PUR-1751
ADDENDUM NO. 5
INVITATION TO BID

HAGERSTOWN REGIONAL AIRPORT
EXPAND/REHABILITATE TERMINAL BUILDING EAST

DATE: Monday, June 23, 2025

DEMOLITION FIRST FLOOR PLAN - ELECTRICAL

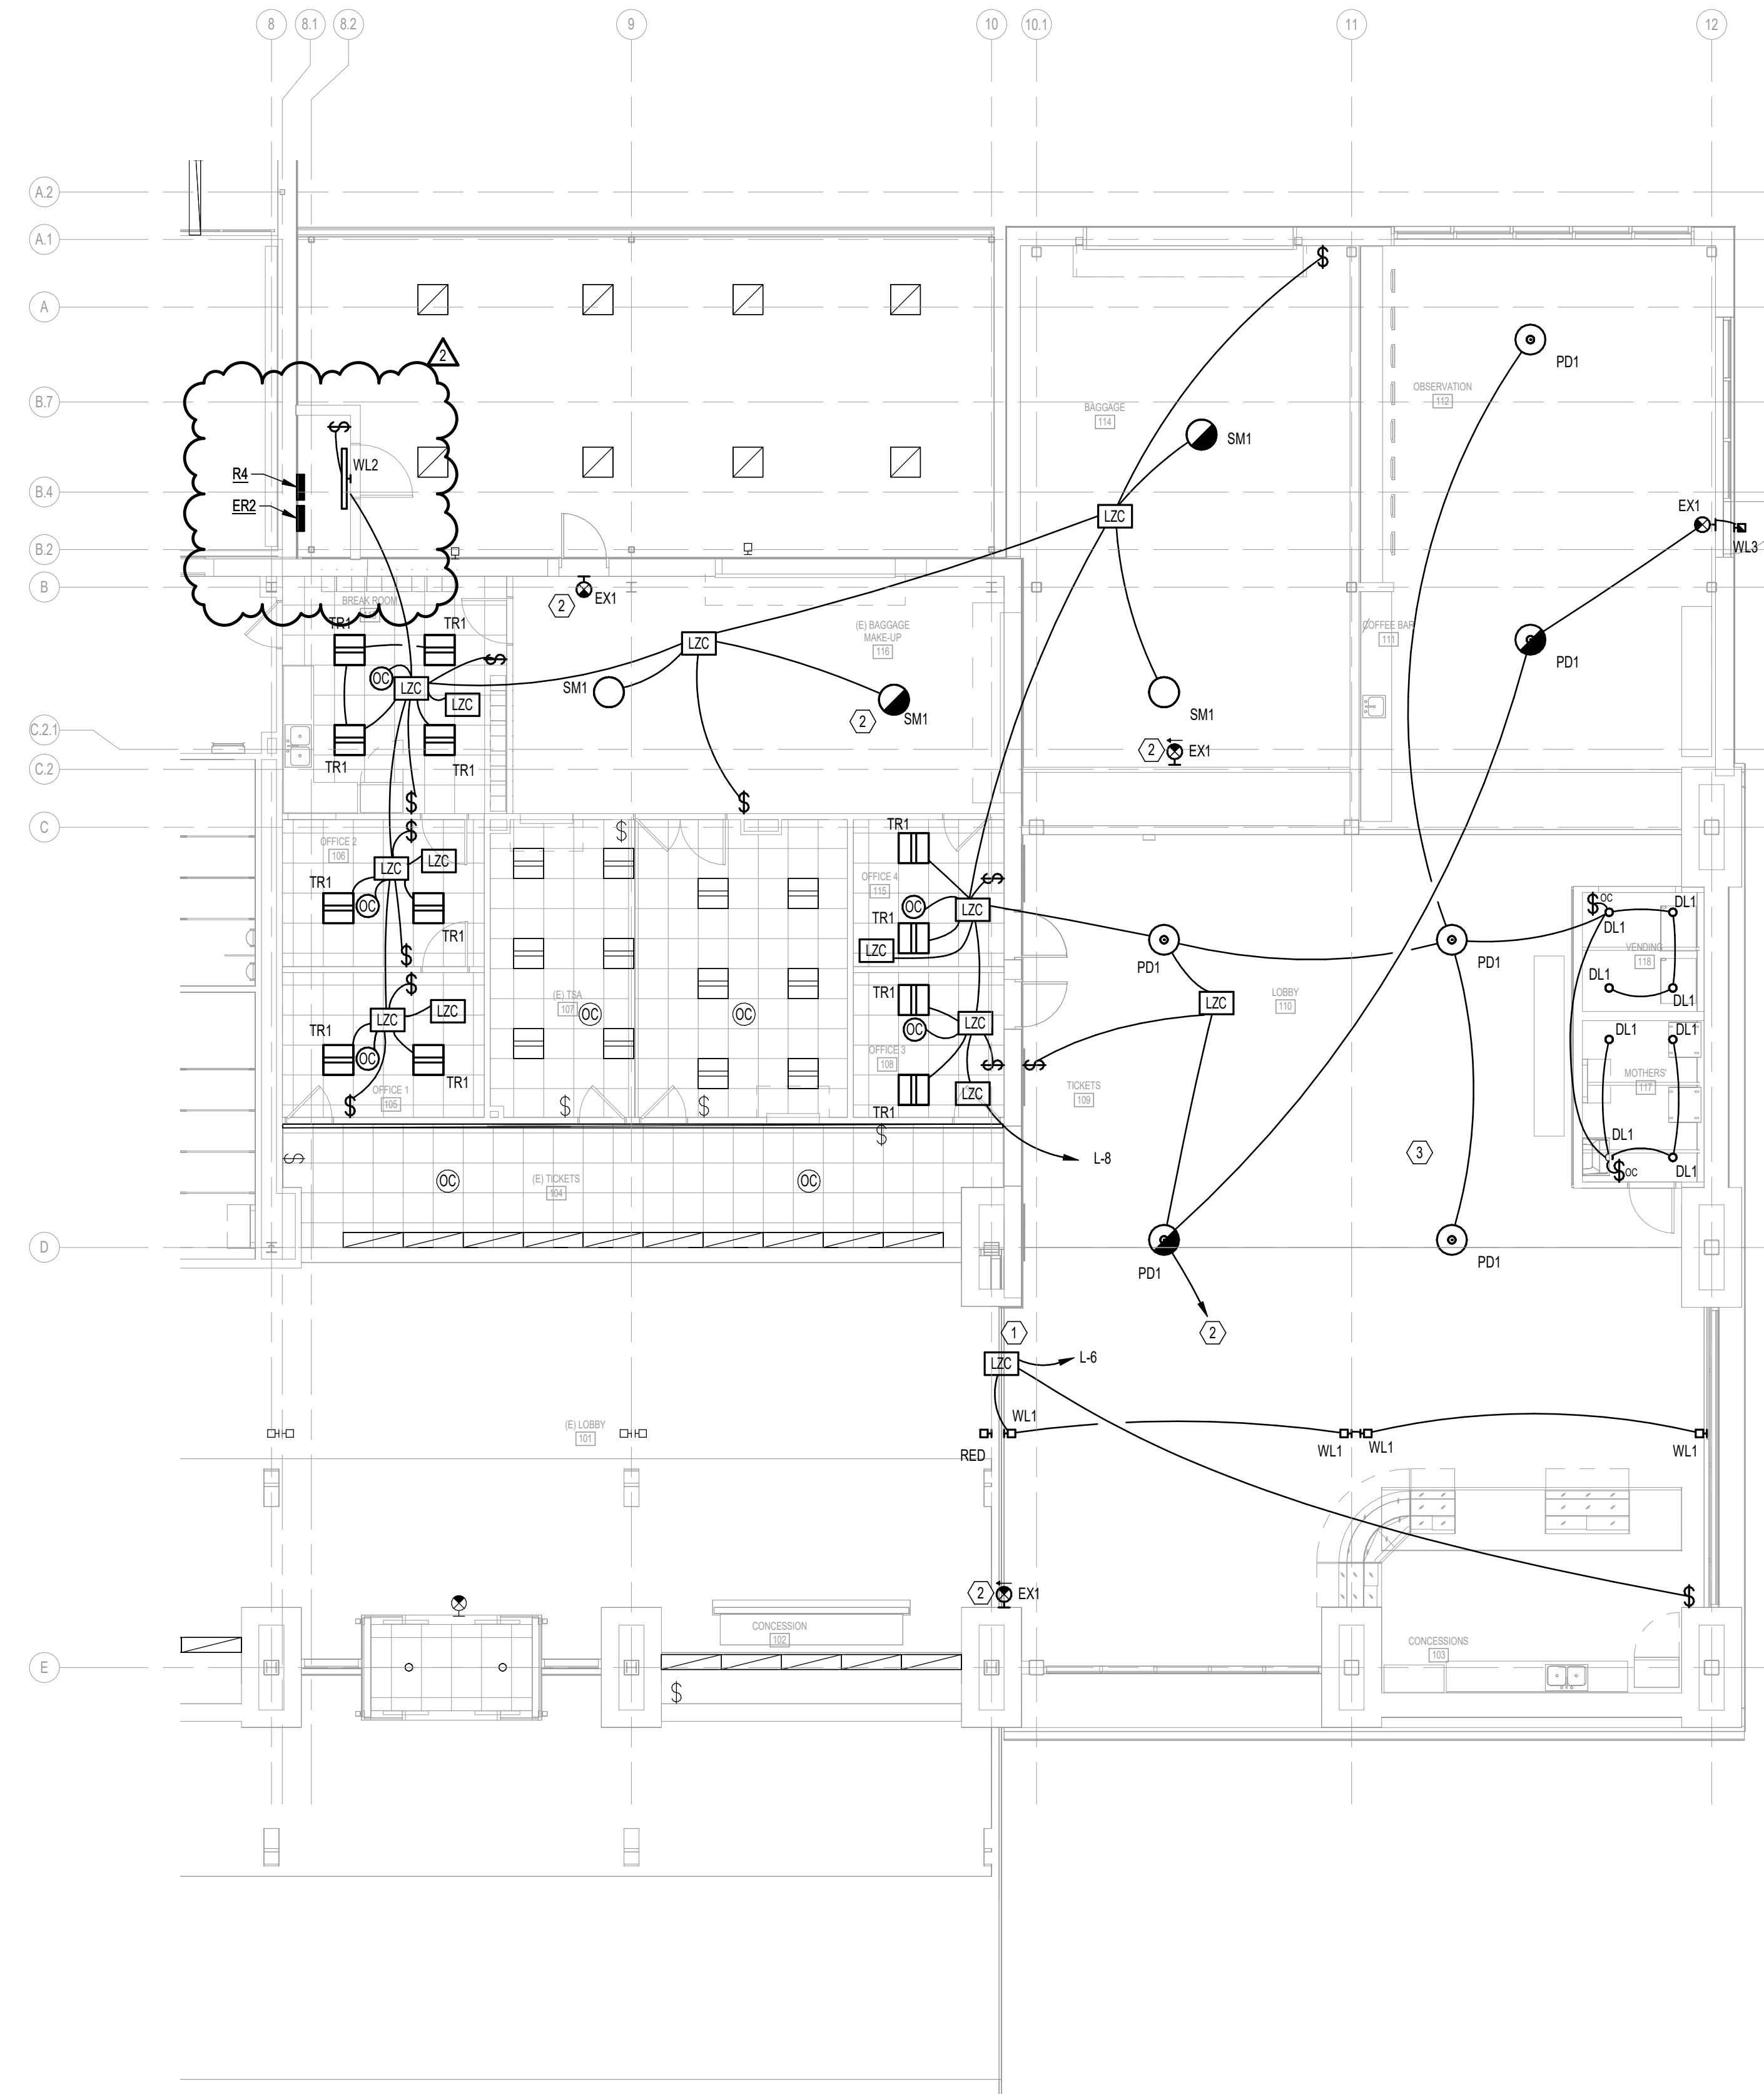
ITEM NO. 10: Inquiry: Ref.: Drawing C1.3 Tie in to proposed wall mounted electrical box

1. This box is not shown on the electrical plans. Please provide a detail depicting this box and the conduits terminating in it.

Response: Part 1 of Item No. 10 herein: This relocated wall mounted junction box is shown on plan sheet E1-1 - Demolition First Floor Plan – Electrical. This box is to receive two (2) 2” RGS conduits. (Attachment B)

1
A1.3
ENLARGED FLOOR PLAN @ NEW WORK
1/8" = 1'-0"
SCALE 0 5 10 15 20 FEET

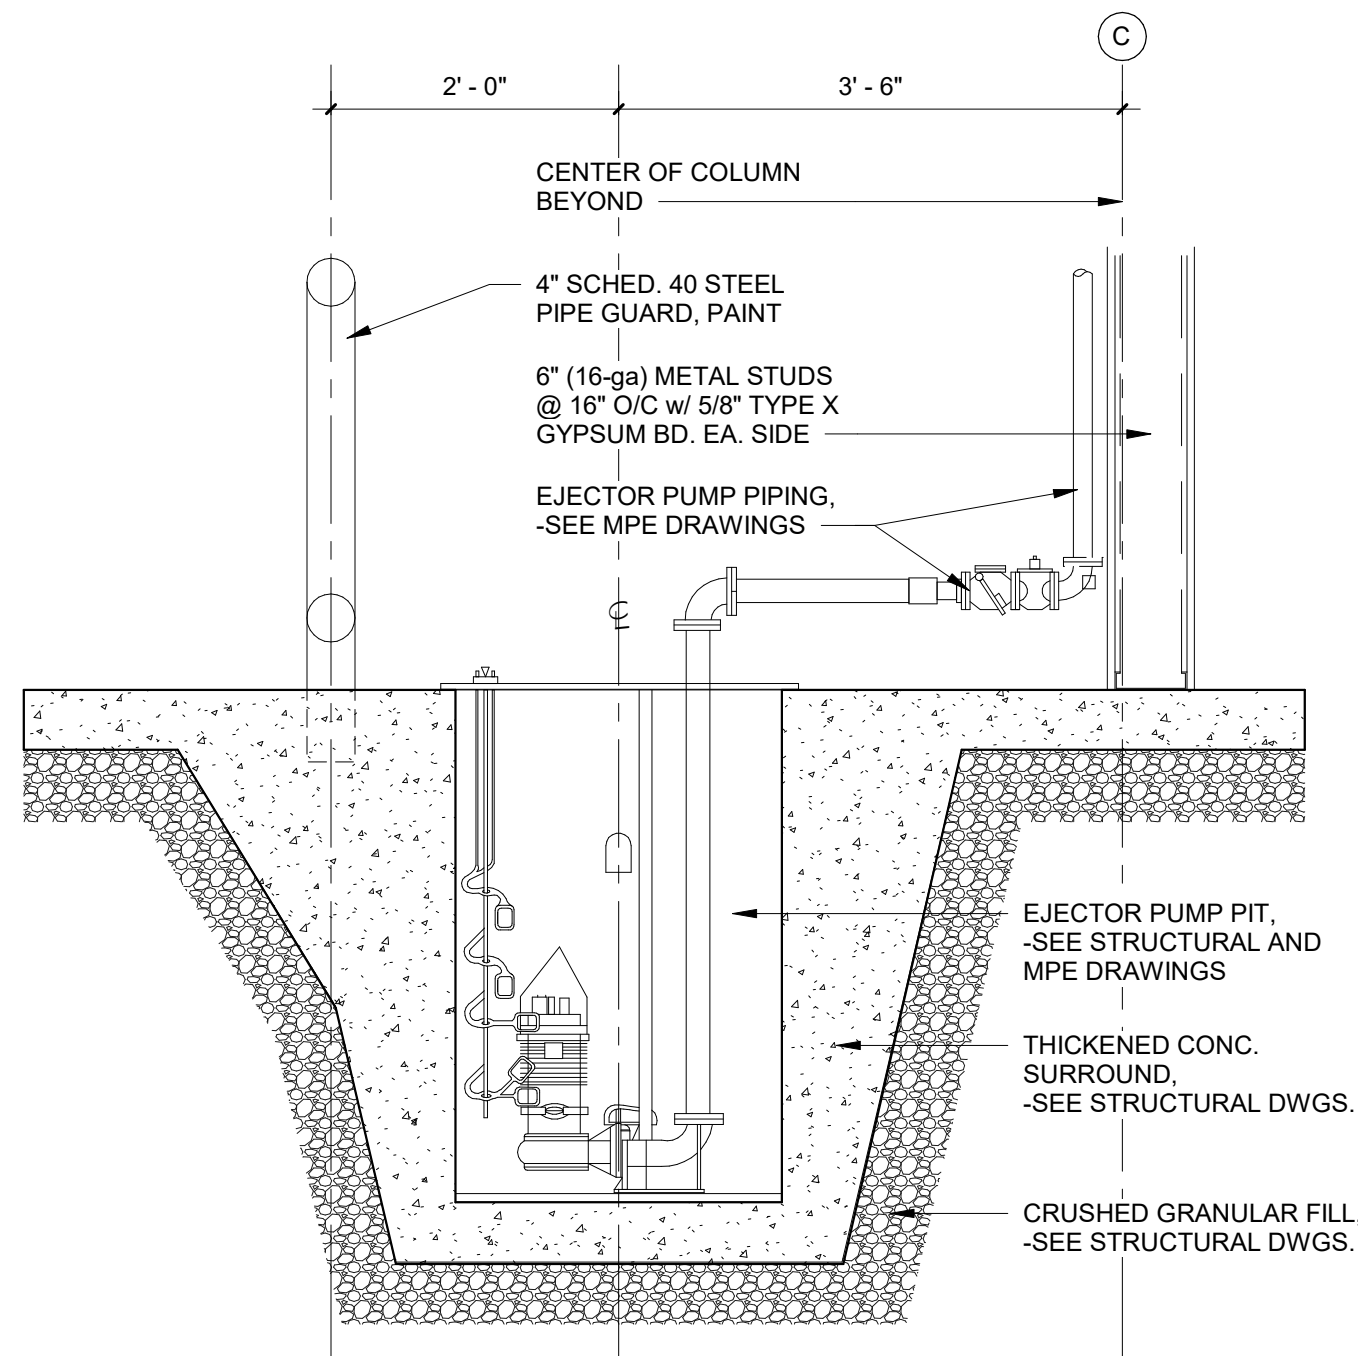
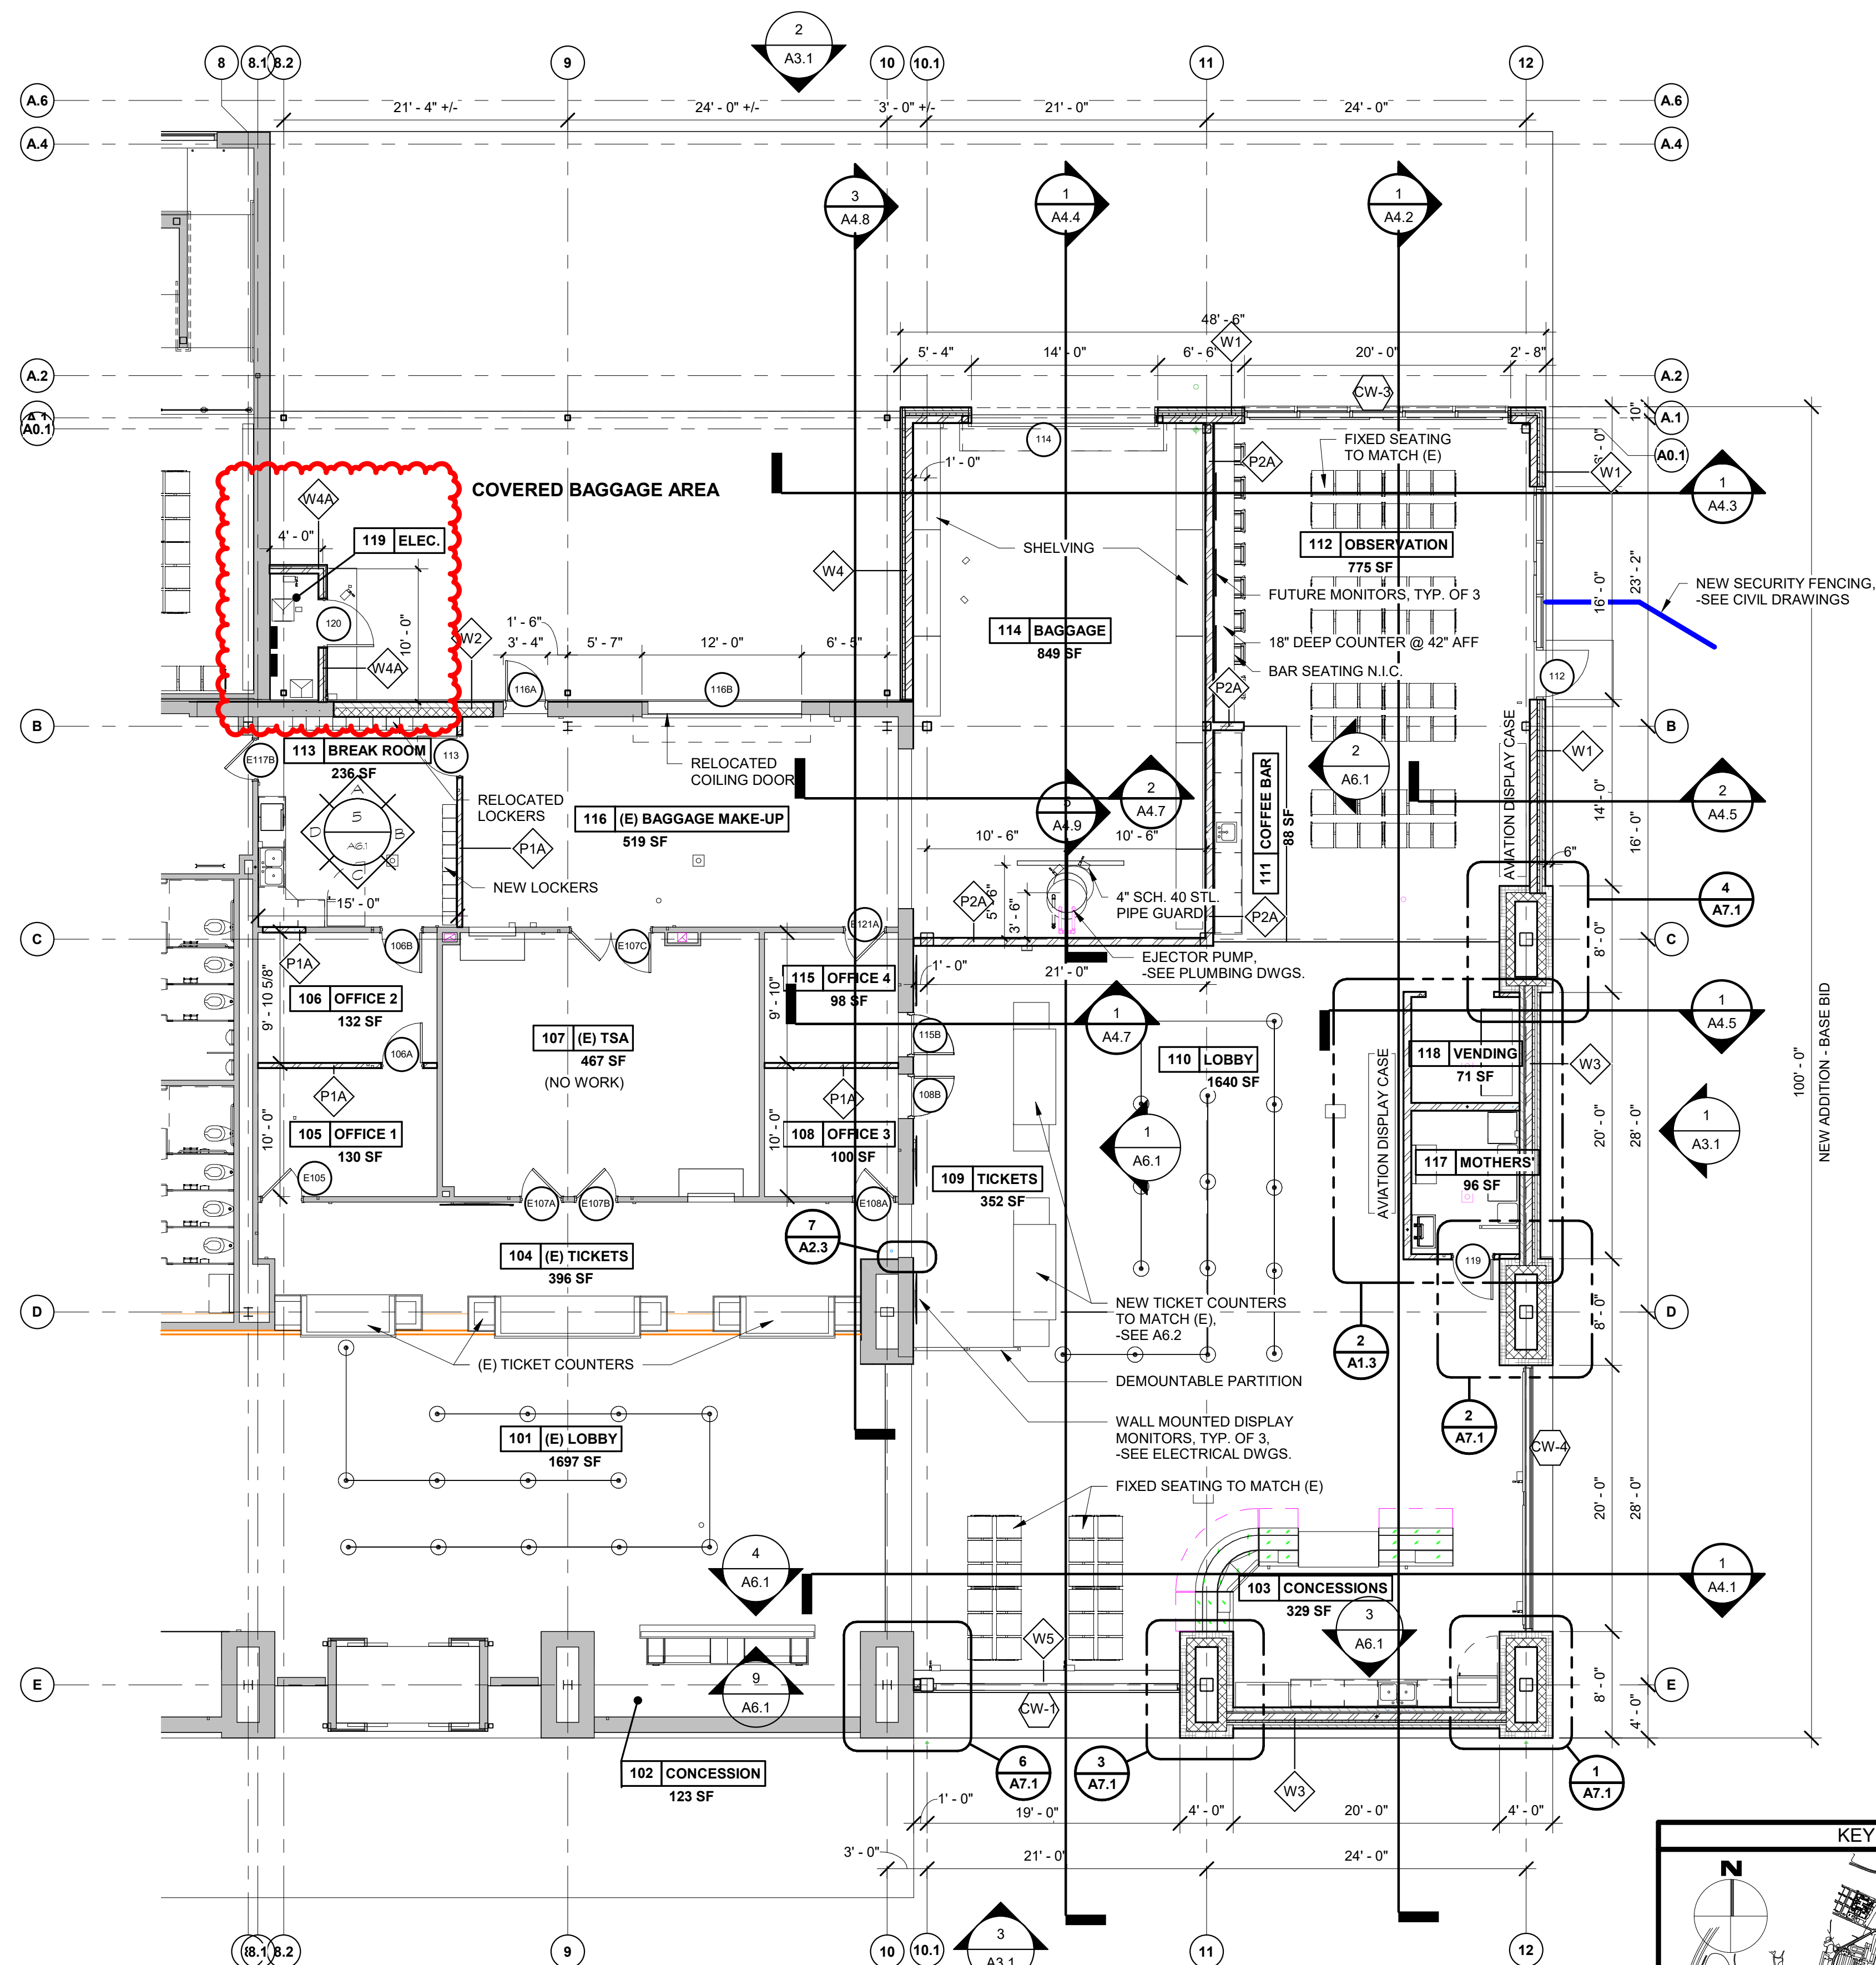
- ITEM NO. 4:** Inquiry: Ref.: New Electrical room construction Phasing
Will the existing roll up door be moved and the new electrical room be constructed before the new electrical panels need to be installed? If not the panels will be exposed to the elements, and need to be protected

will be wall mounted and the existing OHD door to be relocated (116B) would now be a new door. It was discussed that this would to be addressed in Addendum 1, but this did not occur. Please clarify.

- Response: Refer to Drawing Sheet No. A1.3 (Attachment C) ENLARGED FLOOR PLAN AT NEW WORK
- ITEM NO. 5:** Inquiry: Ref.: Security Rough in
Where is the security closet where security conduit should be routed to

Response: Refer to Revised Drawing A1.3 (dated 06.17.2025) (Attachment C) and Revised Drawing D1.1 (dated 06.18.2025). (Attachment B)
